PLAN-021859

15/03/2018

Proposal: Application of four Affordable Intermediate Sale Homes and one Full Market home with associated car parking, garaging, landscaping and bin storage and the creation of 2 new accesses onto Wandleys Lane. This application is a Departure from the Development Plan.
Site: Land South of Wandleys Farm, Wandleys Lane, Walberton, BN18 0QR.
WA/76/17/PL

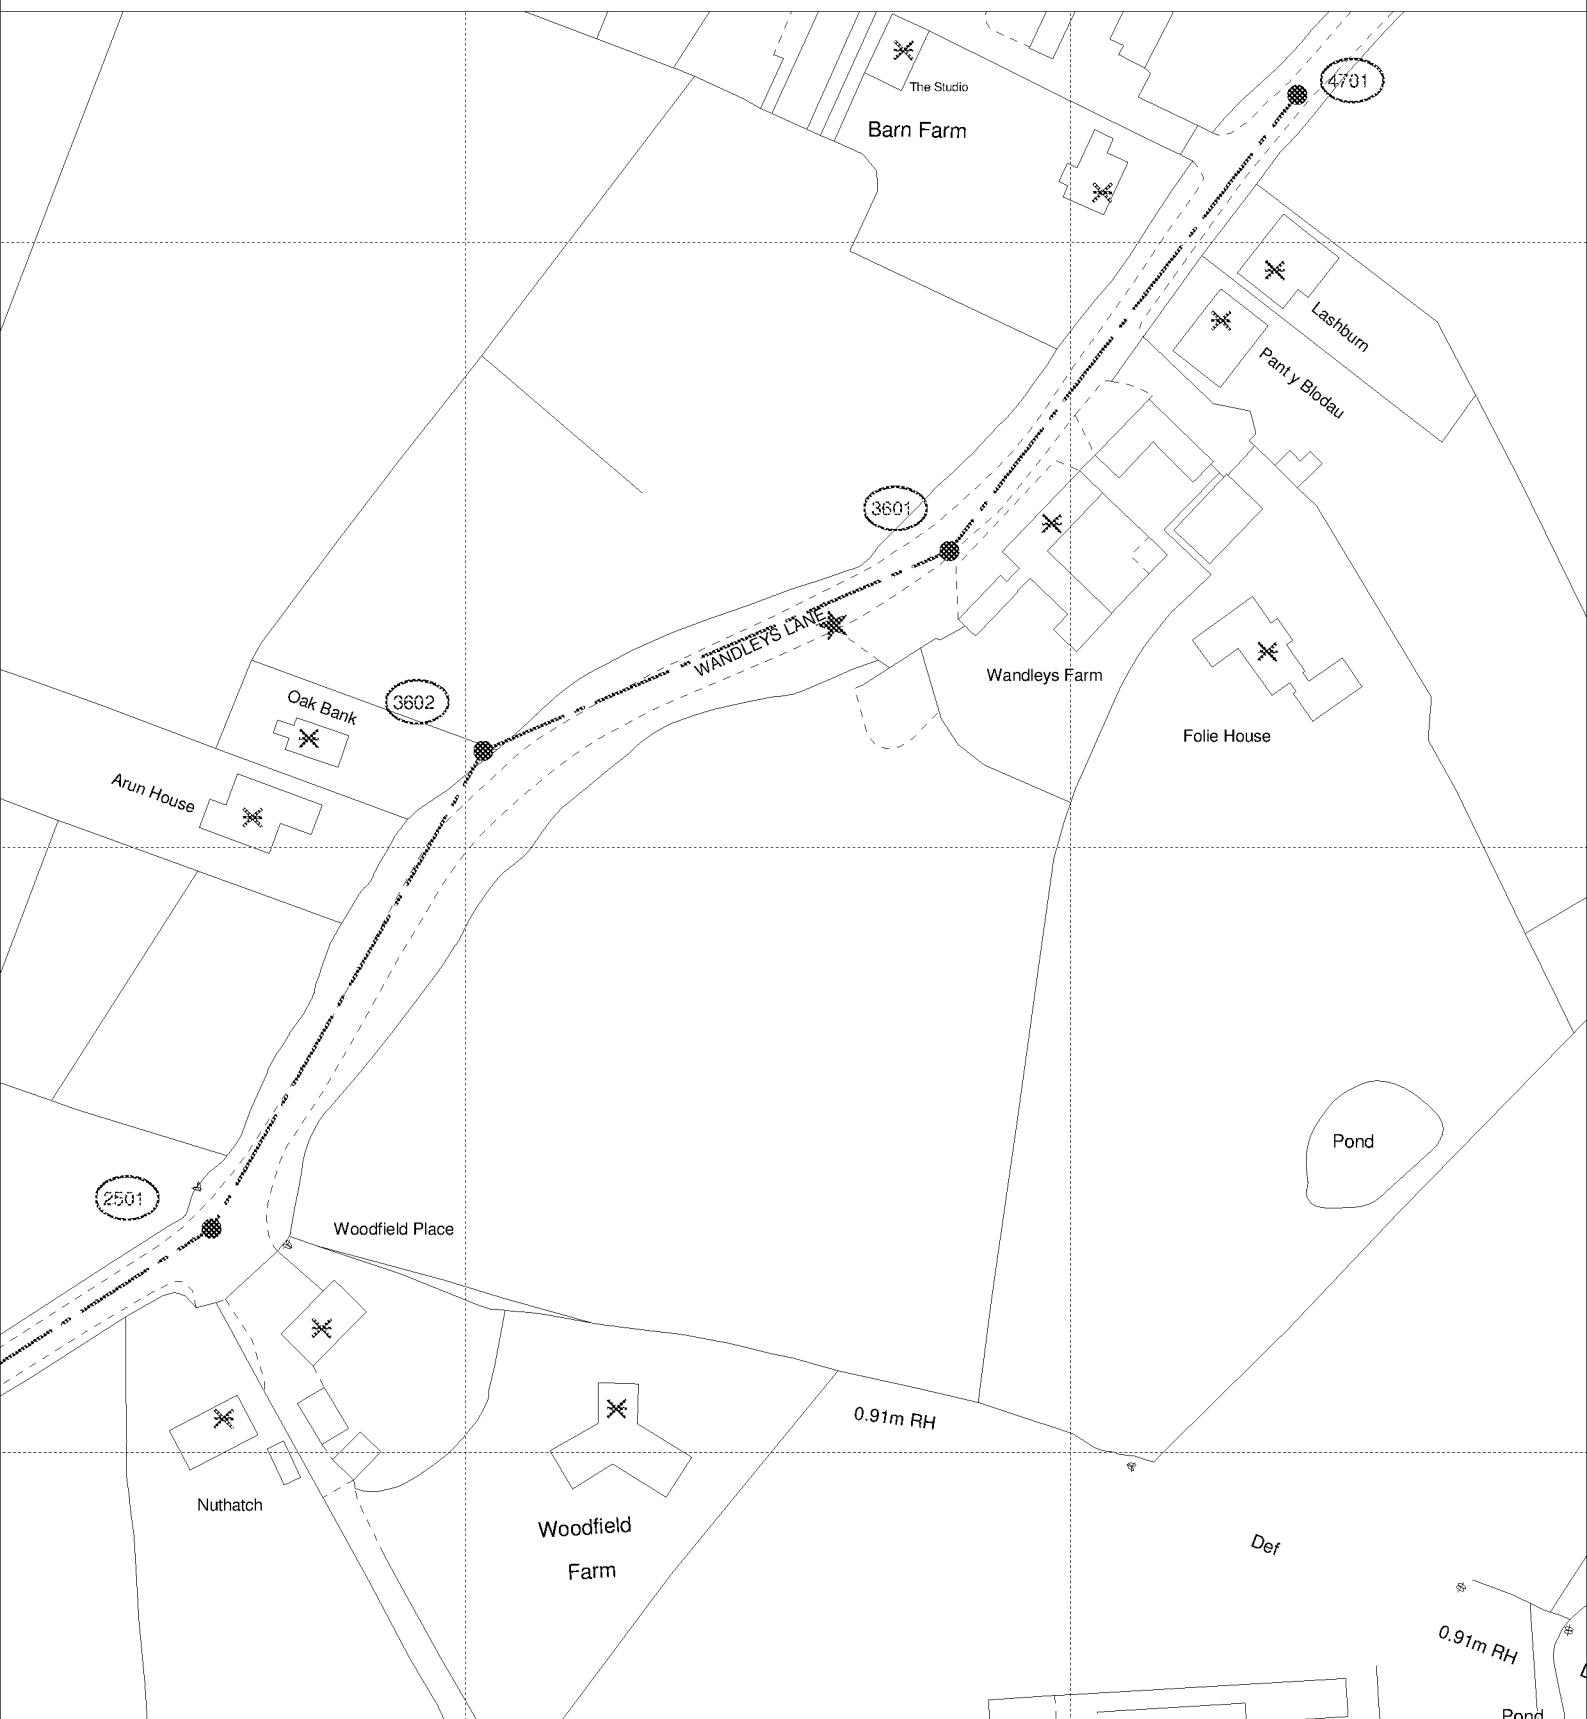
Due to surface water inundation issues in the Lidsey Catchment "The applicant is advised to adopt, where appropriate, the measures in the table "Practical measures to reduce the potential impacts of development".

Developer should look to protect the public sewerage system from inundation and infiltration, which contribute to flooding in unfavourable conditions.
